Entergy Nuclear Operations, Inc.
Pilgrim Nuclear Power Station
600 Rocky Hill Road
Plymouth, MA 02360

SUBJECT: Supplement to Technical Specifications Proposed Change - Administrative Controls for Permanently Defueled Condition

Pilgrim Nuclear Power Station
Docket No. 50-293
Renewed License No. DPR-35

LETTER NUMBER: 2.17.040

Pilgrim Nuclear Power Station
Markup of the Current Technical Specifications Page

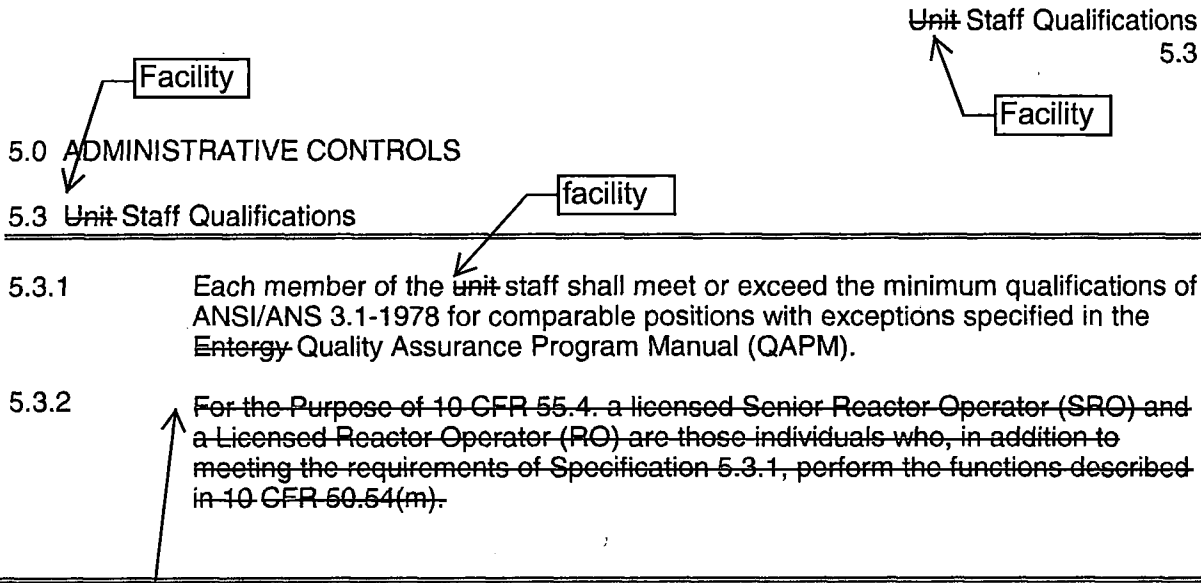
- Page iii Deleted "231" from list of Amendment numbers and drew a revision bar for Sections 5.6 and 5.7.
- Page 1-5 The proposed changes to page 1-4 moved the definition of PROTECTIVE FUNCTION from page 1-4 to page 1-5. Drew a revision bar next to page number 1-5.
- Page 5.0-4 Changed "S" in CERTIFIED FUEL HANDLERS to lower case.
- Page 5.0-12 Repositioned revision bar for change to align with the sentence that was modified.

Attachment 1 to this letter provides a markup of Technical Specifications page 5.0-4 that was omitted in the original license amendment submission. Attachment 2 contains the retyped Technical Specifications pages reflecting the changes described above.

An NRC approved training and retraining program for CERTIFIED FUEL HANDLERS shall be maintained.
